City of San Antonio

Re: **HEB Culebra / 211** **MDP # 004-10**

The Development Review Committee has reviewed **HEB Culebra / 211** Master Development Plan, or **MDP 004-10**. Enclosed is an accepted and signed copy of the MDP for your files. However, please note the following conditions:

HEB-CULEBRA/211
MASTER DEVELOPMENT PLAN #004-10

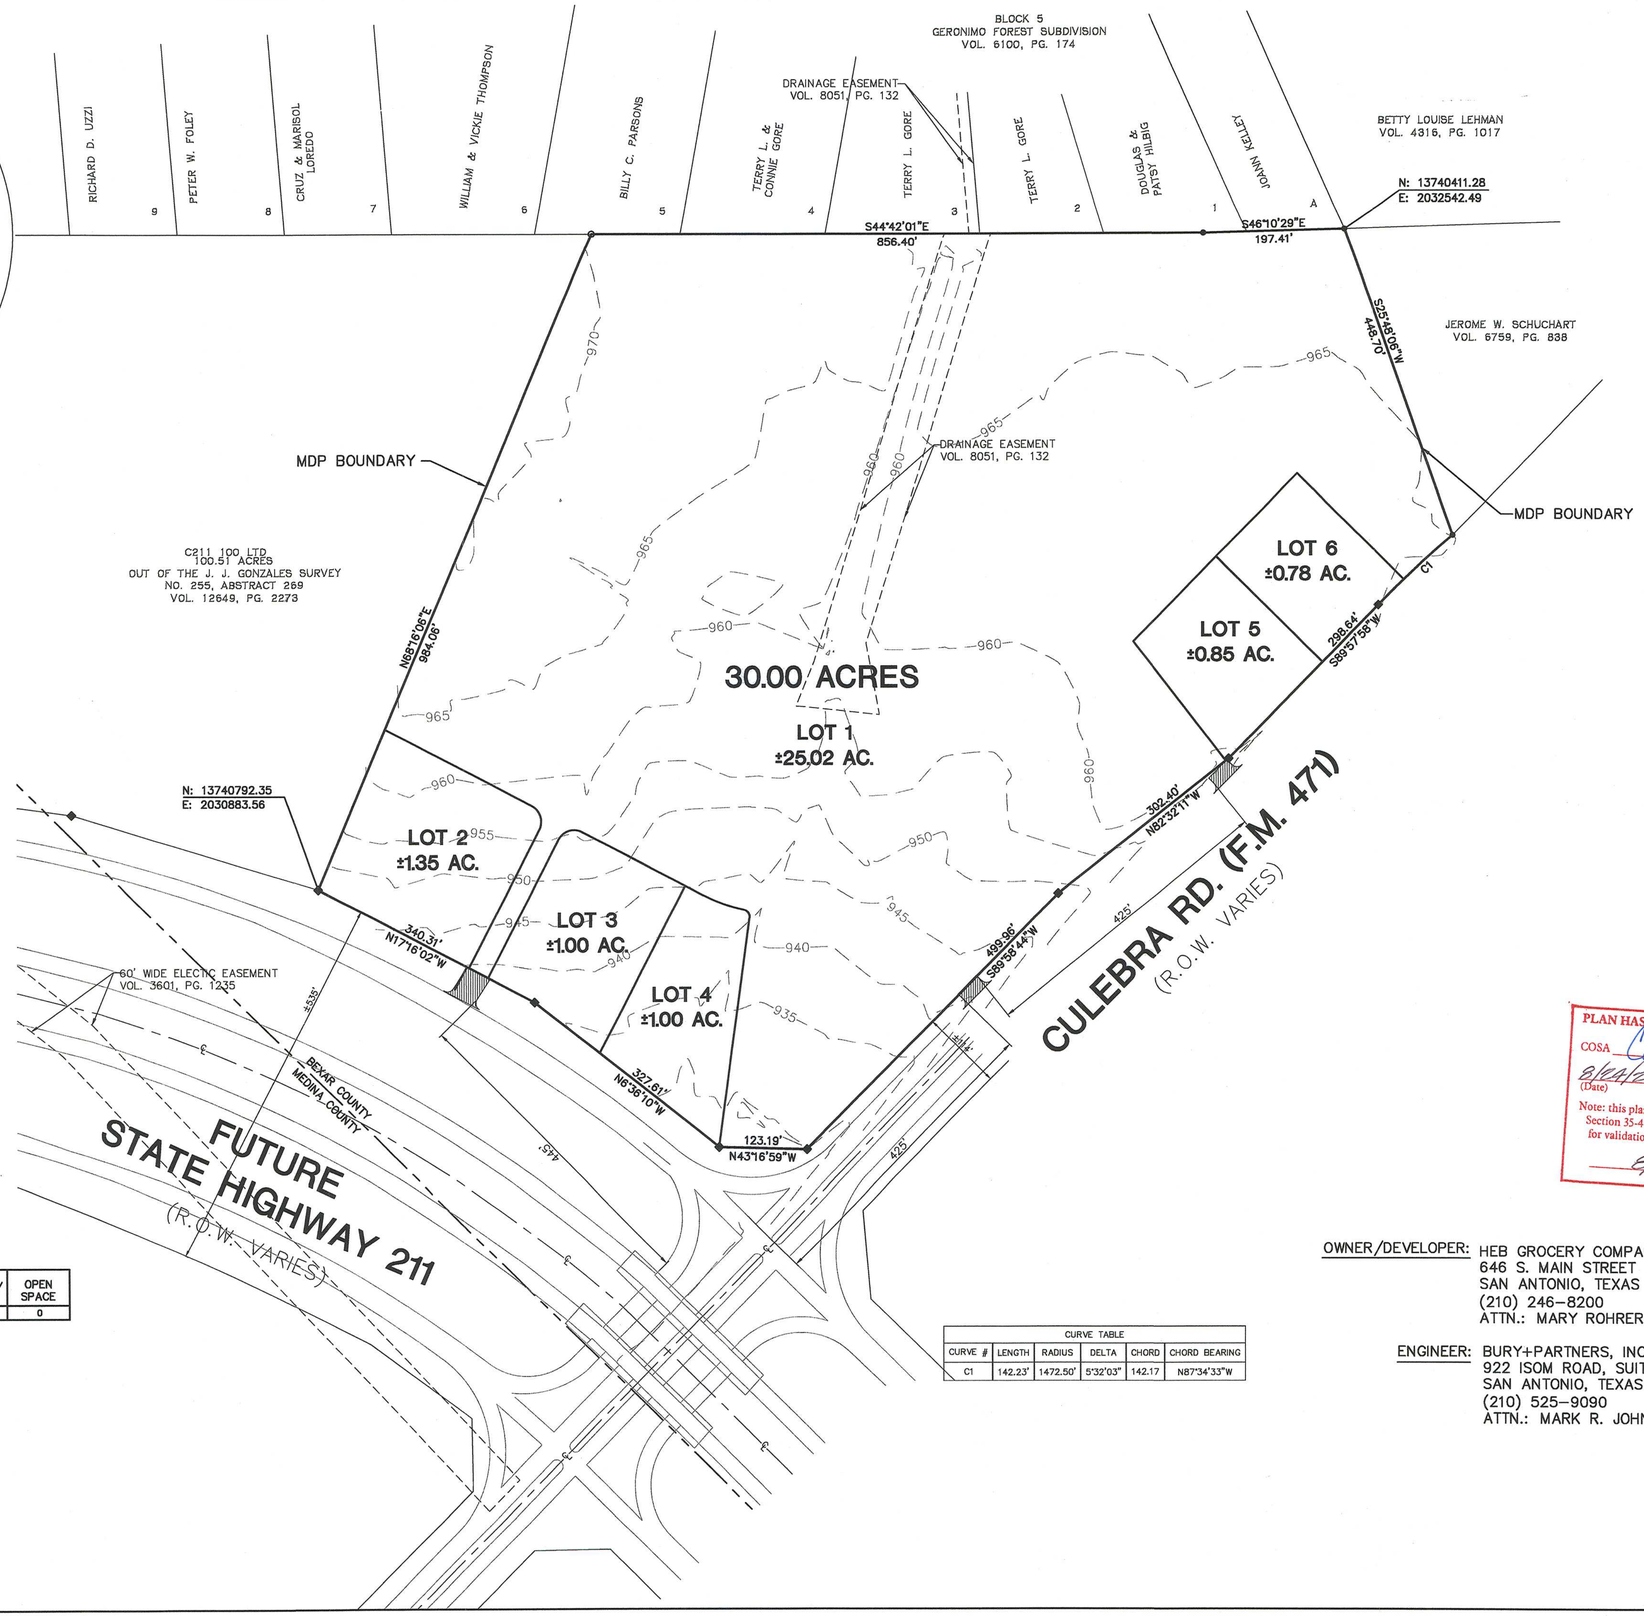
- Culebra Road / SH 211 - The developer shall be responsible for coordinating with TXDOT, Bexar County and/or City of San Antonio Public Works on the installation of a traffic signal at the intersection of Culebra Road and SH 211.

- All driveways along Culebra Road (FM 471) and SH 211 will be approved by TXDOT.

- Right-turn deceleration lanes with storage and bay tapers as it relates to the submitted TIA traffic counts, (UDC - 35-502 (a)(7), subsection C are required for the following driveways;
  - Driveway A
  - Driveway B
  - Driveway C

- Left turn lanes (Temporary until TXDOT improves SH 211 and FM 471 to access control highways) with storage and bay tapers as it relates to the submitted TIA traffic counts, (UDC – 35-502 (a)(7), subsection C are required for the following driveways:
  - Driveway A
  - Driveway B
  - Driveway C

- Subtraction of project driveways will require an update to the TIA under HB 1835 Rough Proportionality requirements.

- Driveway throat lengths for all driveways shall comply with City of San Antonio UDC 35-506, Table 506-7 requirements, to facilitate the safe and efficient flow of traffic.

- All access driveways shall comply with UDC 35-506 (r) (8) Alignment.

- Bicycle lanes along Culebra Road (FM 471) and along SH 211 shall be as required by TXDOT.

- Locations of access points on Bexar County and/or TXDOT maintained facilities are to be approved and permitted by TXDOT and are not determined by the MDP.
